Product Change Notification

CANCELLED 06/25/18

Bourns® Model SRP4012 and SRP4020 Series Shielded Power Inductors Change to Core Channel Design

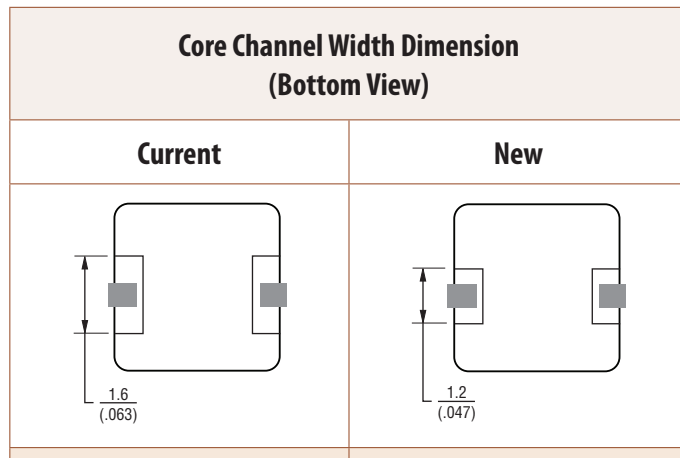
Bourns is changing the core channel design of the [Model SRP4012](#) and [SRP4020 Series](#) Shielded Power Inductors. The terminal positioning will change from 1.6 mm wide to 1.2 mm. Narrowing the core channel will better centrally align the terminal during manufacturing process.

The changes to the inductor core channel design will affect the inductor's form and its quality and reliability should be improved. The inductor's fit and function will remain unchanged. A list of the affected part numbers is shown in Table 1.
